Items to consider for solar ordinance:

Milan Township Solar Ordinance work shop Citizens comments

3/24/2022

1000 ft

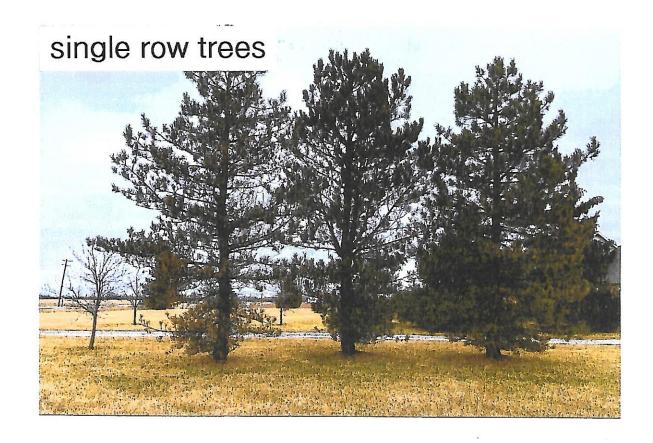
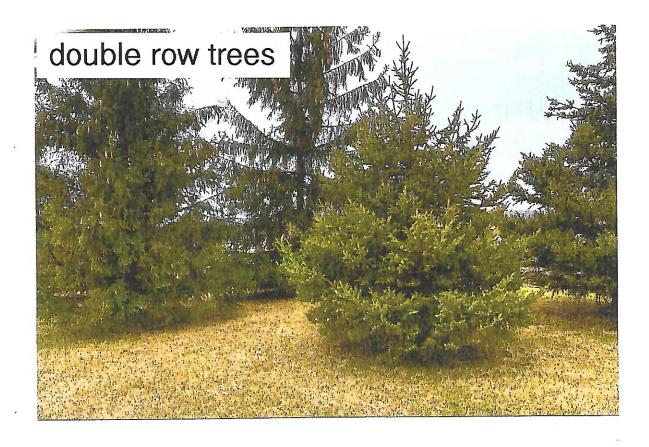
- -See attachment A. photos of solar panels at 1000 ft and 100 ft
- -Pure Michigan Enjoyment

Citizens suggested change: -500ft from any house or property line without a house
-Maintain an option for a future home on all property lines

white pine

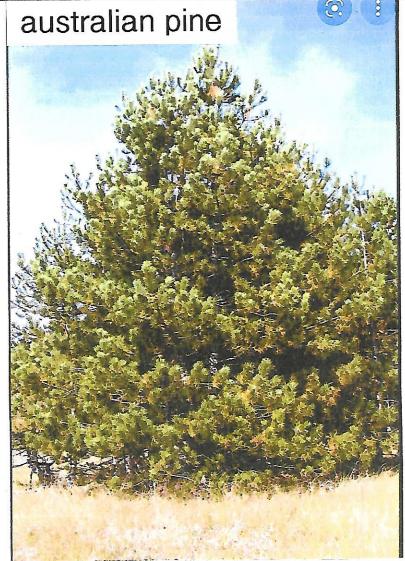
Current plan: -4 ft high trees 15 ft apart. See attachment A photos of this plan
-Native Trees 30 ft apart

- -Berms/trees should be equal to 12 ft +/- in height
- -Who wants to wait 10 years?
- -Native tree should not be an option. Will not make hedge!
- -Should have Licensed Landscape Architect
- -What type of evergreens? The current Ordinance does not specify type of trees
- -Australian Pines, White Pines; White Spruce. See attachment B
- -Residents or no resident should be on all property lines
- -Double row staggered see attachment C
- -Financial Security for maintenance and planting, see item 16.01-13 of Zoning Ordinance 2008-001, need dollar amount for Financial Guarantee

Citizens suggested changes: -should be as high as the panels when inverted
